## EXECUTIVE SUMMARY

This document comprises the issues, observations, questions and concerns of Kelsale cum Carlton Parish Council having considered the latest proposals brought forward by EDF Energy at Stage 4 of the Pre-Application Consultation process.

**Figure KcC 1**

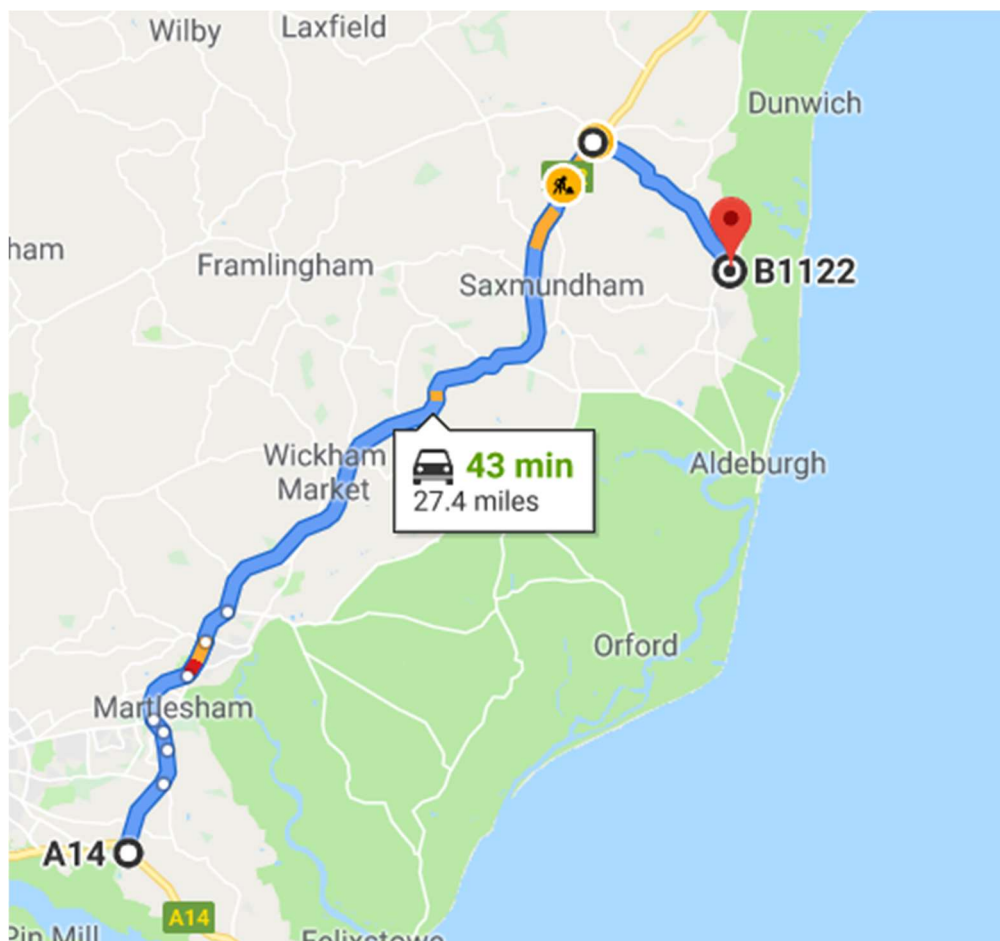
However, despite EDF Energy still not quantifying the total number of vehicle movements required to construct Sizewell C, it is self-evident that the route 'Z' into the Main Development Site, whilst being shorter than the B1122, is still considerably longer than necessary. (see **Figure KcC 1** below)

Consequently, as EDF Energy persist in taking a minimum of 85% of HGV traffic well north of Saxmundham (along with associated; cars, LGVs and bus traffic), KcC PC believe this is unnecessarily detrimental to all of the foregoing interests when compared to routing traffic east off of the A12 south of Saxmundham (estimated minimum net saving of 6 miles per delivery (3 miles per HGV movement)).
